SOUTHERLY WWTP-PRIMARY & AERATION  
IMPROVEMENTS

**Re: Storm Water Inspection at Southerly WWTP – Primary & Aeration  
Improvements / Franklin County  
Permit #: 4GC02526\*AG**

Figure 1: Wash out area

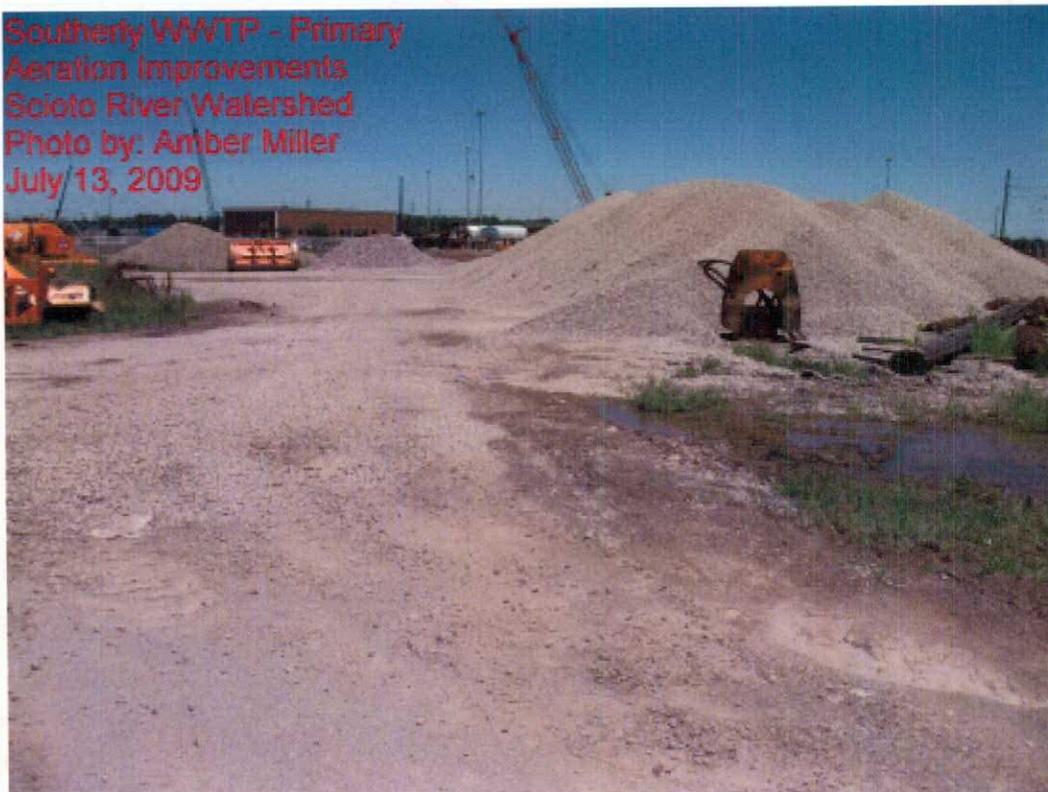
- Silt fence must be installed by the wash-out area to prevent material from being washed off-site (See Figure 1).
- The entrances to the site (See Figures 2 and 3) must be stabilized to minimize off-site vehicle tracking.
